Re: Terasen Gas Inc. - Fort Nelson Service Area (TG Fort Nelson) 2011 Revenue Requirements Application for Changes to the Revenue Stabilization Adjustment Mechanism ("RSAM") Rate Rider and Delivery Rates effective January 1, 2011 (the "Application")

Response to the British Columbia Utilities Commission ("BCUC" or the "Commission") Information Request ("IR") No. 2

1.0 Reference: Muskwa River IP Bridge Crossing

Attachment 9.1.1

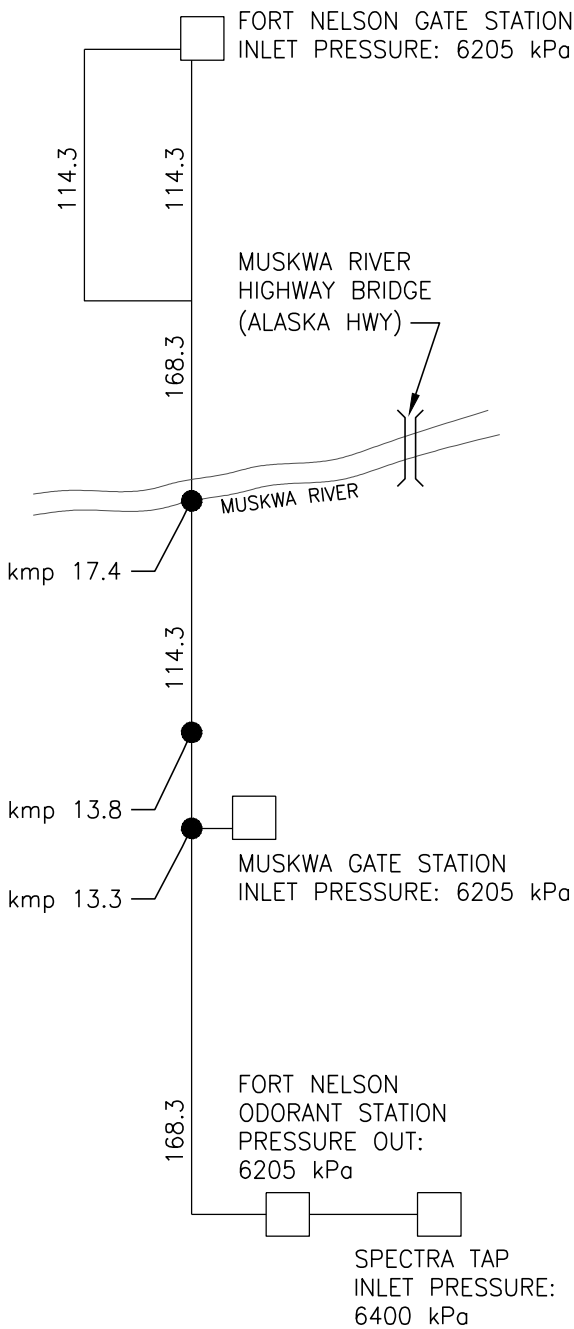
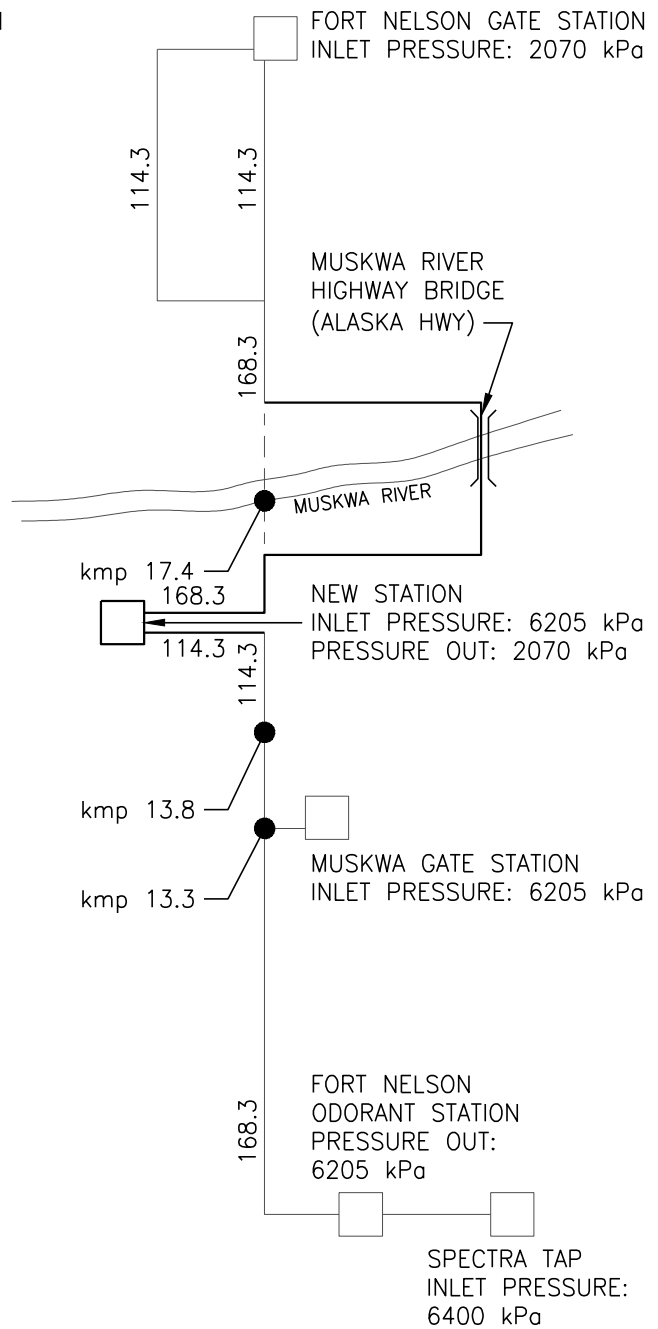
9.1.1 Please provide details regarding the potential overlap of the Muskwa Gate Station project and the impact of the timing and selection of a river crossing option.

The following discussion is intended to clarify the facilities associated with the Fort Nelson lateral.

The gas that flows through the Muskwa River Crossing supplies a station called the Fort Nelson Gate Station. It is this station that could be reconfigured from a TP-DP station to an IP-DP station if a new TP-IP station was installed on the south side of the Muskwa River in order to use the highway bridge (the IP Bridge Option). In this option, there is no station relocation, but there is a modification to an existing station and the installation of a new station. The first paragraph of Section 4.1 of Exhibit B-5, Appendix B discusses the possibility of "replacing and relocating" the Fort Nelson Gate Station. However, what is meant by this wording is the relocation of the TP-IP pressure reduction, not the physical relocation of facilities. The bulleted list of Project components following this introductory paragraph is correct and consistent with this response.
